UNITED STATES PATENT AND TRADEMARK OFFICE

| APPLICATION NO. | FILING DATE | FIRST NAMED INVENTOR | ATTORNEY DOCKET NO. | CONFIRMATION NO. |
|-----------------|-------------|----------------------|---------------------|------------------|
| 10/707,805 | 01/13/2004 | Yi-Nan Chen | NTCP0027USA | 1804 |

Office Action Summary

**FIG. 10**

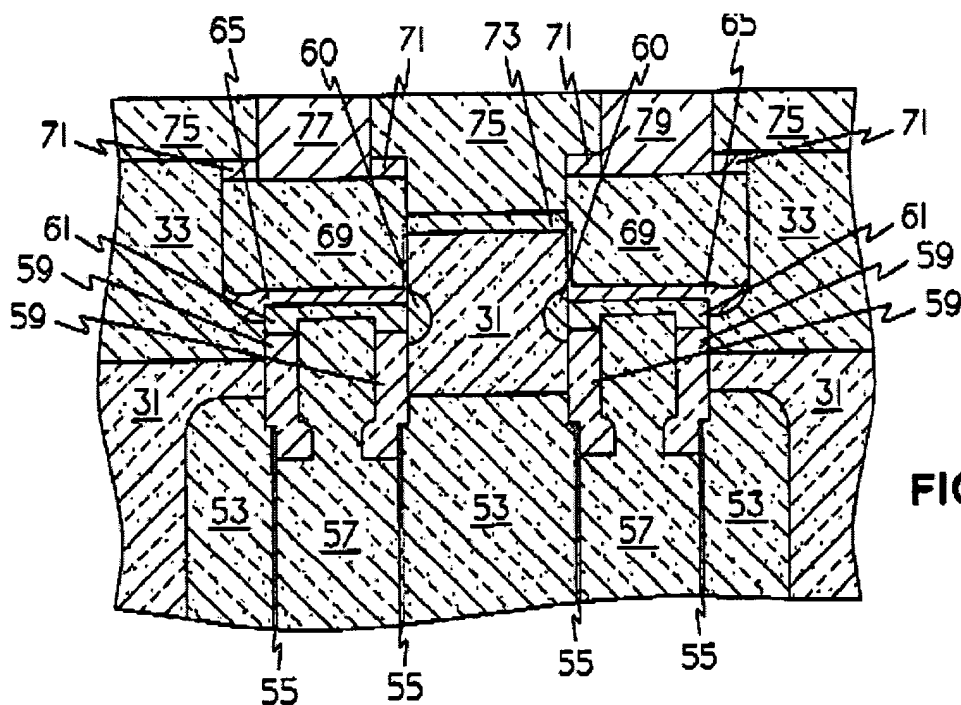
Regarding claim 1, Furukawa teaches (figs. 1-10) an isolation structure of a trench capacitor (75 in the middle, fig. 10), the trench capacitor being disposed in a deep trench (39) of a substrate (31) and comprising a conductive layer (57, 69) in the deep trench and a collar oxide layer (59) disposed on a surface of a sidewall of the

deep trench, the isolation structure comprising: a first isolation portion (portion of 75 on the top left and right) covering the conductive layer and filling a top opening of the deep trench (fig. 10), the first isolation portion having a first thickness; and a second isolation portion (the isolation portion of 75 that is thicker) directly contacting the first isolation portion and surrounding the deep trench without overlapping the deep trench (fig. 10), the second isolation portion having a second thickness larger than the first thickness (the 2nd isolation portion goes deeper than the 1st isolation portion).

Regarding claim 2, Furukawa teaches the entire claimed structure of claim 1 above including the second isolation portion is disposed by a side of the collar oxide layer (59), near the conductive layer (57, 69) and the collar oxide layer (59) without being located on the conductive layer (57, 69).
